Revised PPR Scheme

Revised PPR Scheme

This chapter provides a brief update on the minor revision of the structural design of the transfer structure above the Heritage Buildings to ensure there is no clash with any roof or parapet to the Australian Hotel. Physically, it manifested itself by raising the Level 03 slab by 750mm. This did not affect any of the internal layouts at this level and the reduction in the floor-to-floor height does not affect the floor-to-ceiling height of 2.70m.

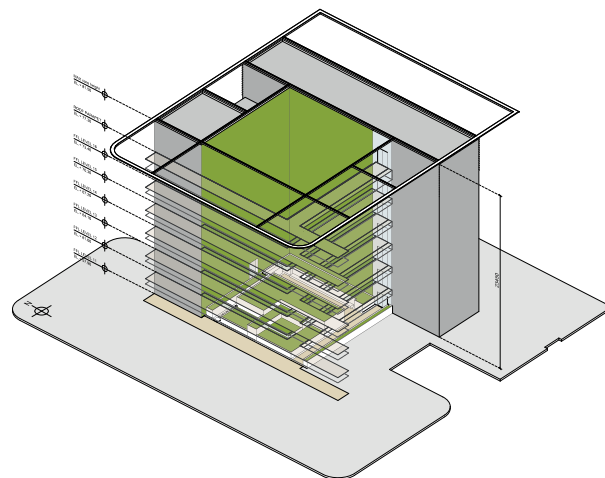
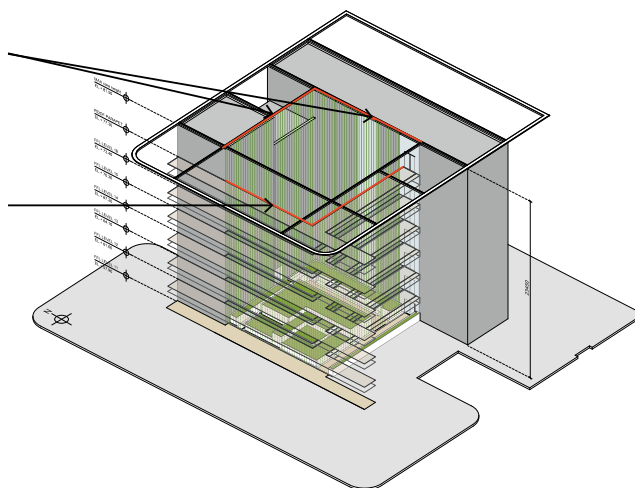
The main strategy here is to unify the overall space as a vertical garden where the walkways and link bridges are connected by the use of cascading plants from planters along their edge addressing the void while climbing plants are introduced along the blank walls which are encouraged by the use of vertical cable trellises. The use of the planting on the walkways has the added benefit of providing shading to the general circulation routes as well as a degree of privacy. The images and diagrams on the following pages highlight these changes and provide an indication of the potential look, feel and details of the final space.

North and East: Vertical green system
connected to roof canopy edge.

South and West: Vertical green system
connected to top/bottom of bridges

Hotel Level 13, Residential Level 11 - Ventilation Slots

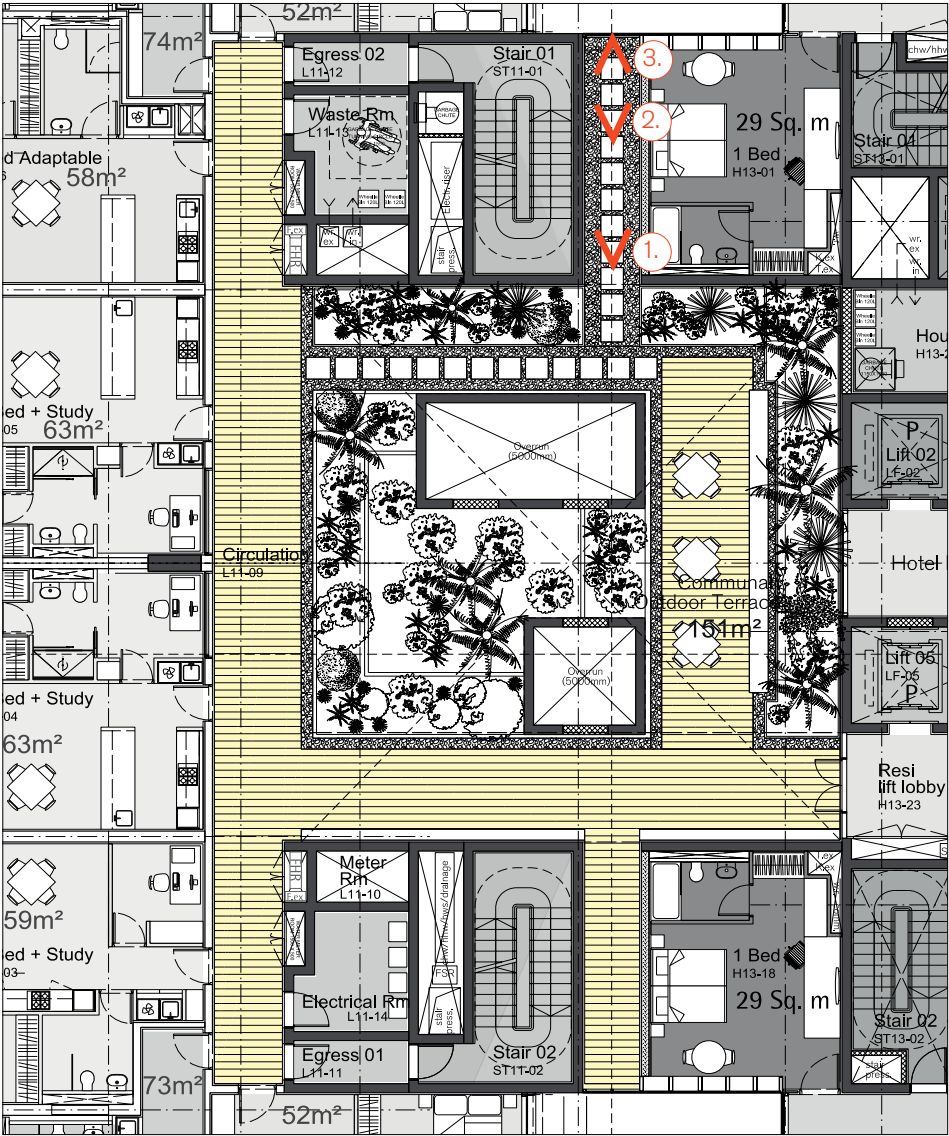
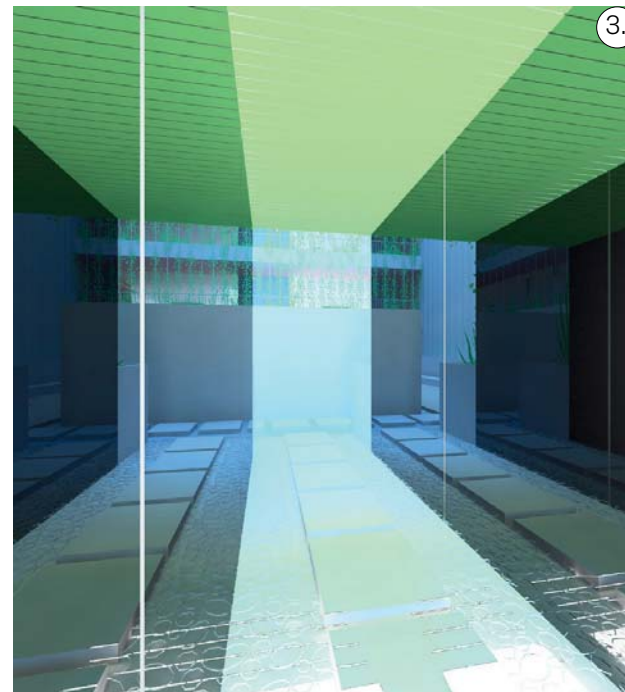
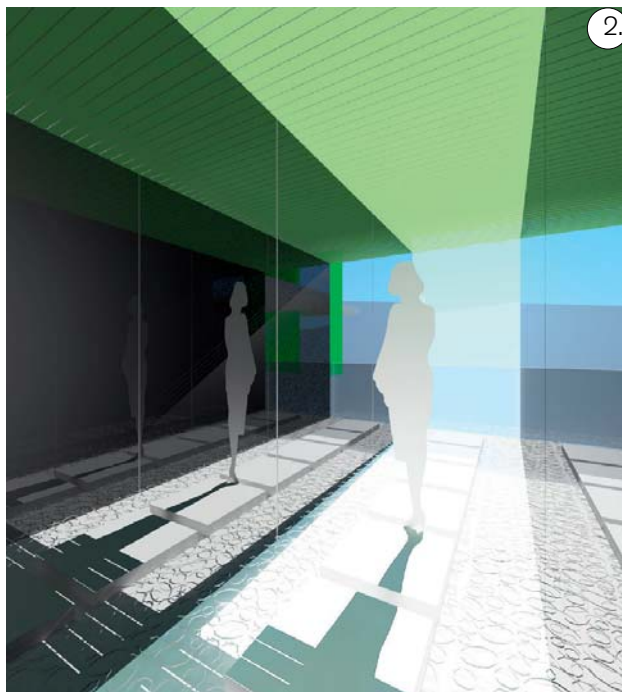
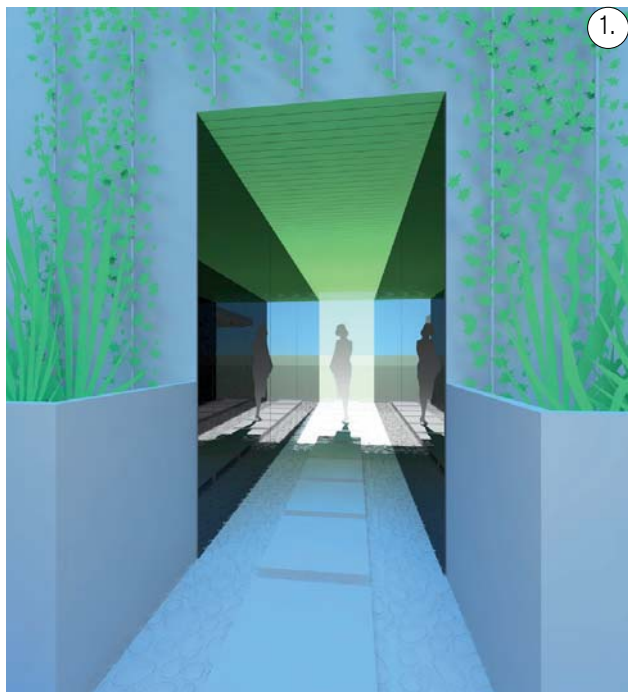
The revised design of the residential now also looks to utilise the ventilation slots at the base of the void on both the northern and southern boundary of the plan.. Predominantly used to help provide fresh air into the space and a single storey in height, it is now proposed to allow residents to use these spaces as a way to connect with the surrounding city by providing views directly to the north or south. The aim is to provide an alternative type of space within the void which may be more private or quieter. This is also reflected in the proposed finishes, where the use of mirrored finishes and discrete lighting help to create a unique space. The images and plan on these pages indicate where the slots are and provide an indication of the look and feel these areas may have in the final design.

Rooftop Canopy
Top Roof Level

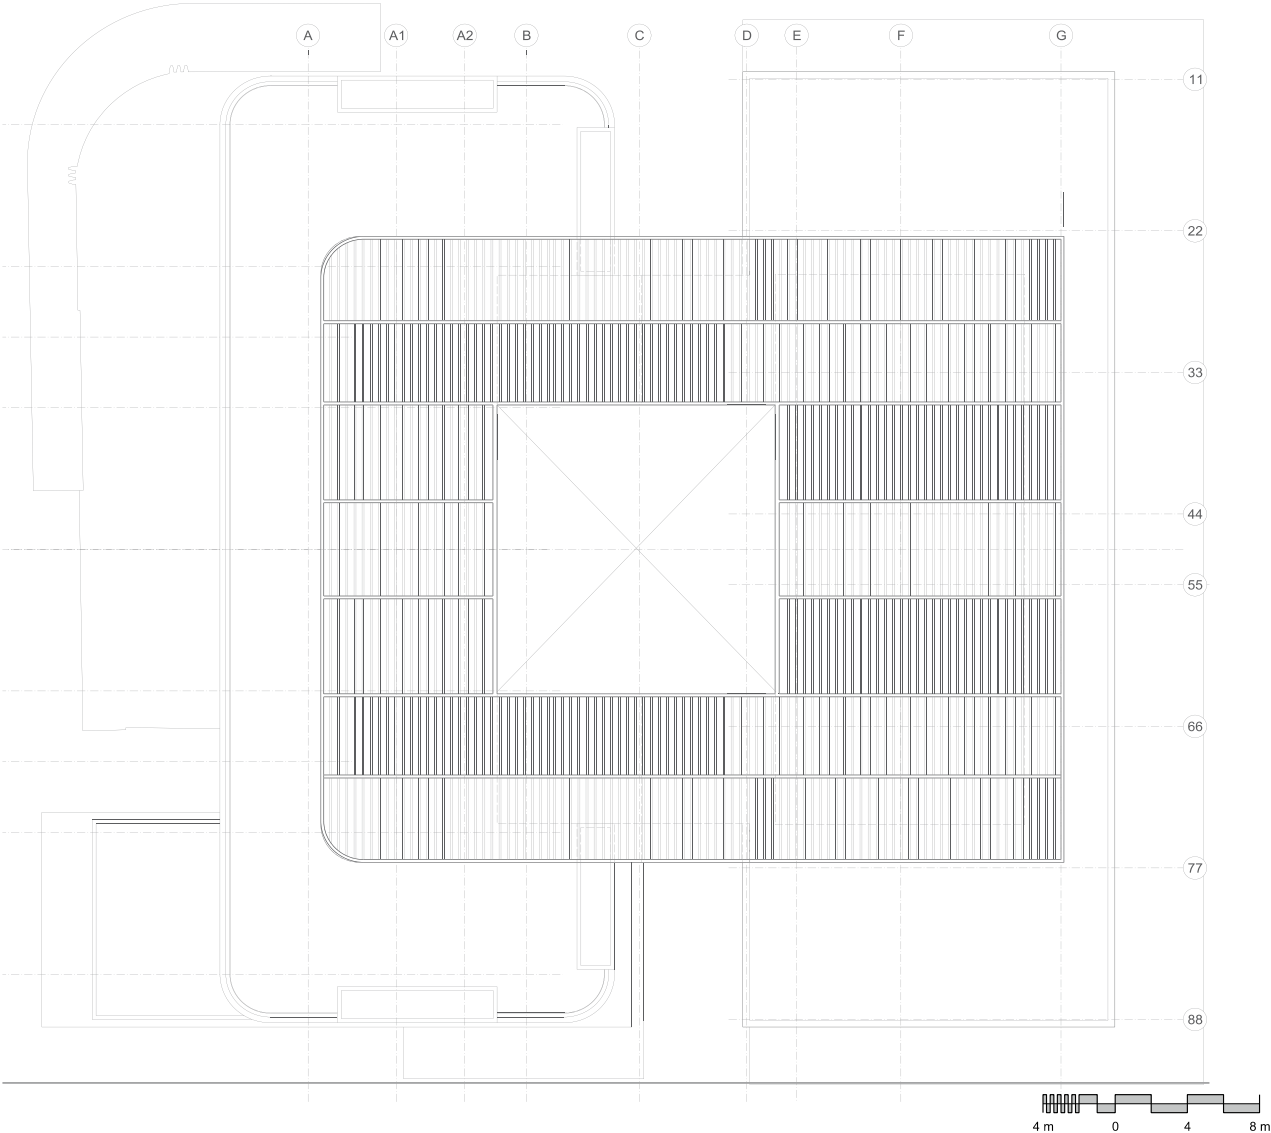
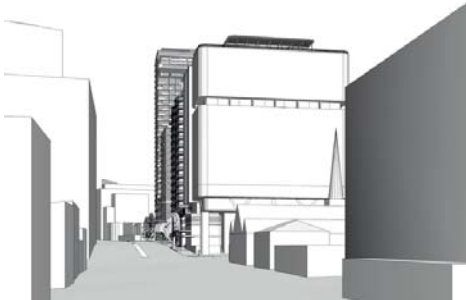
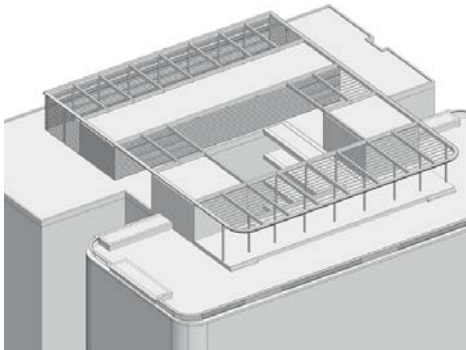
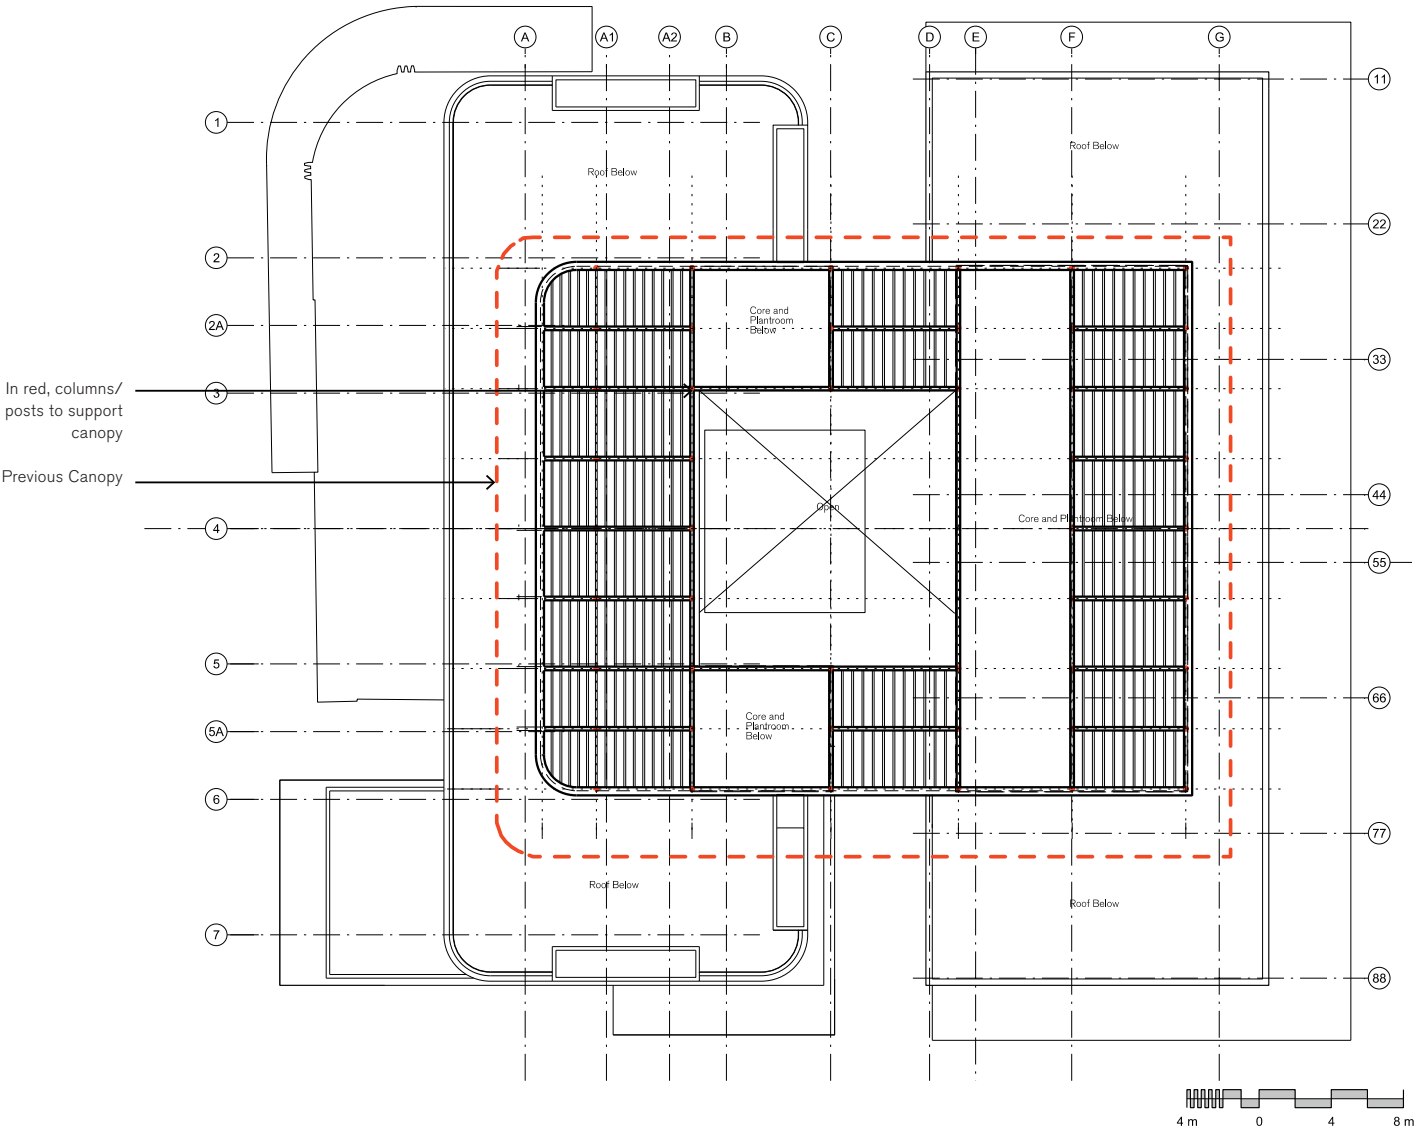
The design of the rooftop canopy has progressed since the SSDA submission. The revised design now proposes for a slightly smaller canopy in plan. This mainly a result of the structural design having progressed and the refinement in the landscaping design of the residential void. In the case of the latter, it has affected the design of the rooftop canopy due to how the canopy can now be viewed from within the space either at the bottom of the void or from the general circulation along the south and west. The intent is to ensure the canopy is read as a floating plane with minimal sight of the columns or cross-bracing required to support it.

From a distance, there is a minimal change in its appearance on top of the building with the reduction of its size in plan having no adverse effects on the cast shadows on the surrounding environs; if anything, the extent of shadows have been reduced. The revised design for the canopy also improves on the current SSDA proposal in relation to the 3D massing set out in the Concept Masterplan.

Transfer Structure above Heritage Building
North Elevation - Revised PPR Proposal

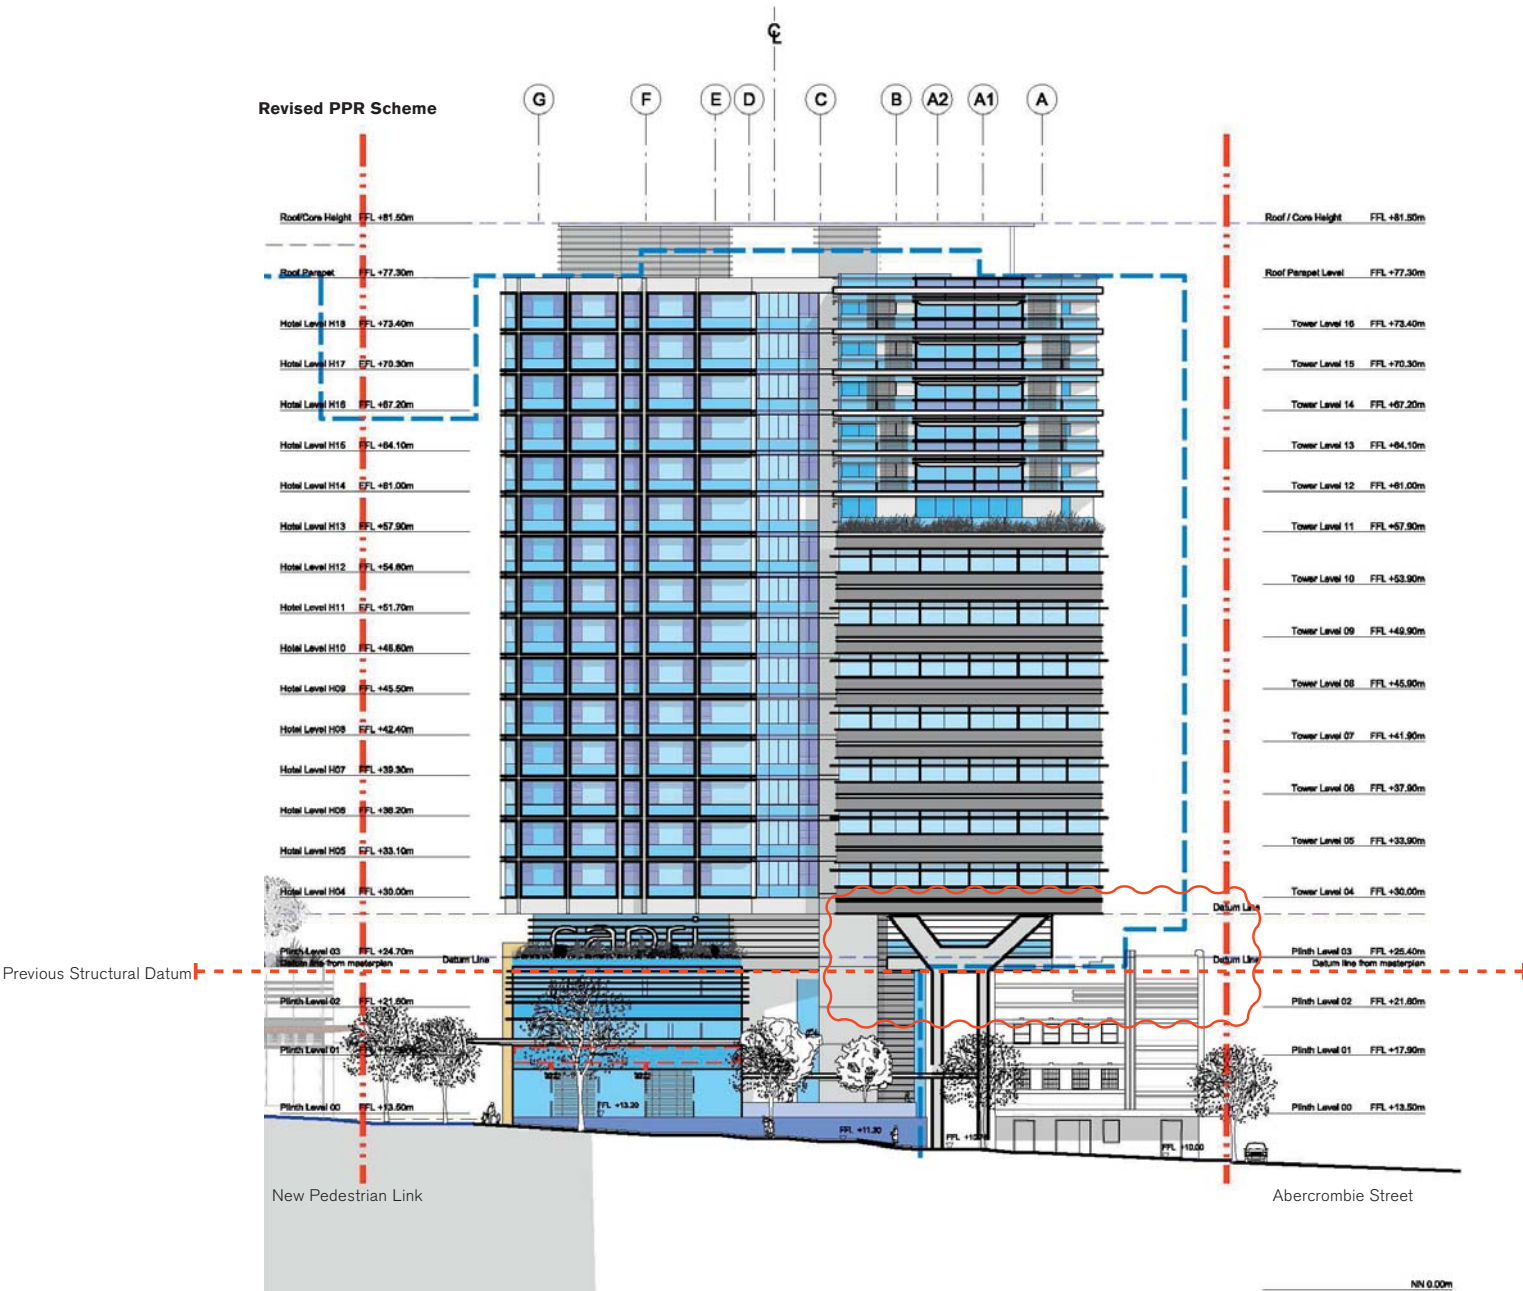
The elevations on these pages show the current and proposed northern facades along Broadway for Block 4N. The change highlight the subtle revision to the Level 03 finished floor datums and transfer beam
